UNITED STATES
DEPARTMENT OF THE INTERIOR
BUREAU OF LAND MANAGEMENTFORM APPROVED
OMB No. 1004-0135
Expires January 31, 2004**HOBBSDO****SUNDRY NOTICES AND REPORTS ON WELLS***Do not use this form for proposals to drill or re enter an
abandoned well. Use Form 3160-3 (APD) for such proposals.***SUBMIT IN TRIPLICATE - Other instructions on reverse side**

Cactus QN Ut #2

Yates Drilling Company
Cactus Queen Unit #2
Unit J, Section 27-12S-31E
Chaves County, NM
30-005-20997
Sundry attachment
April 8, 2009

Permanent Abandonment of Federal Wells Conditions of Approval

CACTUS QUEEN UNIT #2
(Garner Federal #9)
Sec 27, T12S-R31E CHAVES CO., NM
30-005-20997

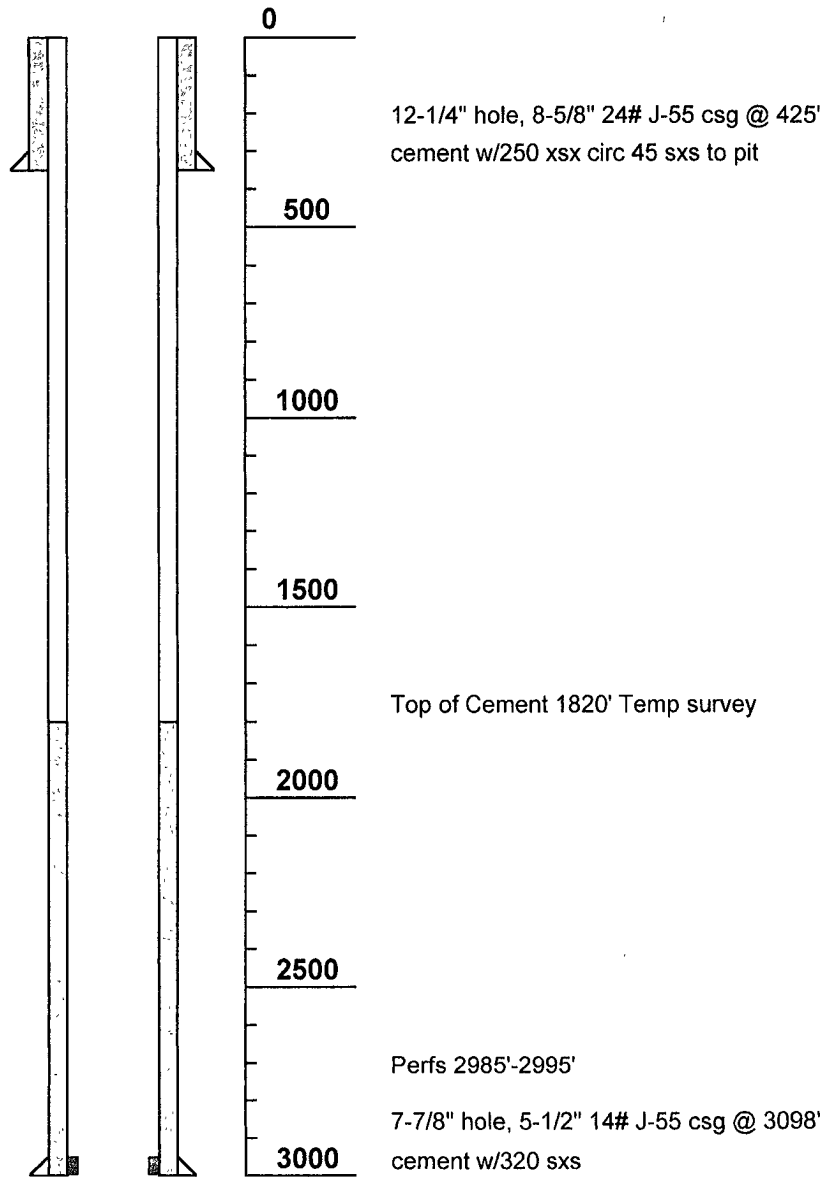
1. Set CIBP @ 2,950', mix and circulate 10# mud inside 5 1/2" casing to surface
- * ~~2.~~ Spot 25 sxs Class "C" cement plug on top of CIBP
- ~~3.~~ Perforate 5 1/2" casing @ 1400'. TOS
4. Set packer @ 1,350'. Mix and circulate 10# mud out 5 1/2" annulus
5. Set cement retainer @ 1,350'. Pump Class "C" cement out of 5 1/2" annulus to surface + 5 sxs. cnt. on top of CIBP.
6. Spot Class "C" cement plug in 5 1/2" casing from 480' to surface
7. Erect dry hole marker, remove equipment and clean location.

* 25 sxs. cnt. @ 2150', BOS.
